Access Compliance Report

Public Rights-of-Way

(Curb Ramps)

Intersection ID: 14739	Main Street: DARTMOUTH_PL	Cross Street: PROVIDENCE_RD	Location: SW
ADA ID: C6B76CDC21DE	Ramp Type: PerpDiag	Initial Pass/Fail: Fail	Overall Compliance: No
Severity Score: 21.25			
Codes/Mitigation Info/Possible Solution		Field Measurements/Component Compliance

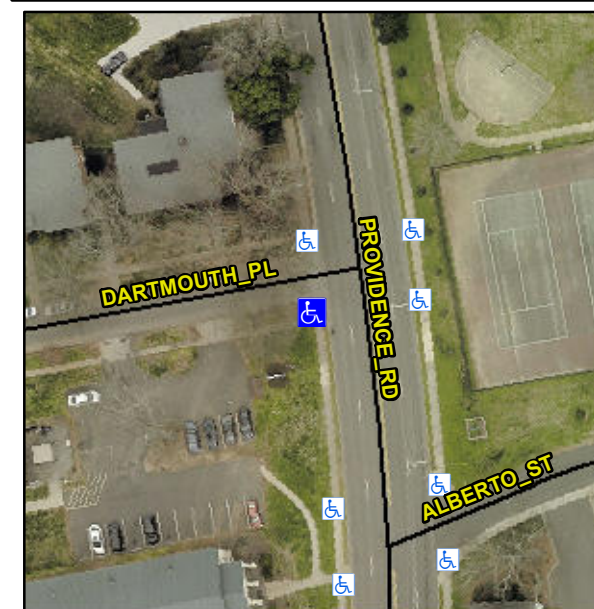
Not Found, R304.5.1, R304.5.3

Compliance	Description	Data	Compliance	Description	Data
N/A	Ramp Length (in)	92.0	Yes	Ramp Slope (%)	7.4
No	Ramp Width (in)	40.0	No	Ramp XSlope (%)	5.8
N/A	Flare Type LT	N/A	N/A	Flare Type RT	N/A
N/A	Flare Slope LT (%)	N/A	N/A	Flare Slope RT (%)	N/A
N/A	Flare Traversable LT?	N/A	N/A	Flare Traversable RT?	N/A
N/A	Landing Length (in)	N/A	N/A	DWS Provided?	N/A
N/A	Landing Width (in)	N/A	N/A	DWS Contrast?	N/A
N/A	Landing Slope (%)	N/A	N/A	DWS Length (in)	N/A
N/A	Landing X Slope (%)	N/A	N/A	DWS Full Width?	N/A
N/A	Landing Curb? (Y/N)	N/A	N/A	DWS Offset (in)	N/A
N/A	Shared Landing?	N/A			
N/A	Gutter Ponding?	N/A	N/A	Gutter Slope (%)	N/A
N/A	Gutter Lip Ht (in)	N/A	N/A	Gutter X Slope (%)	N/A
N/A	Painted X Walk1?	No	N/A	Painted X Walk2?	No
	X Walk 1 Direction	To E		X Walk 2 Direction	To N
N/A	X Walk 1 Width (in)	N/A	N/A	X Walk 2 Width (in)	N/A
	X Walk 1 Slope (%)	2.7		X Walk 2 Slope (%)	1.0
	X Walk 1 X Slope (%)	2.4		X Walk 2 X Slope (%)	5.3

Remove & Replace Curb Ramp With Two New Directional Ramps or Equivalent.
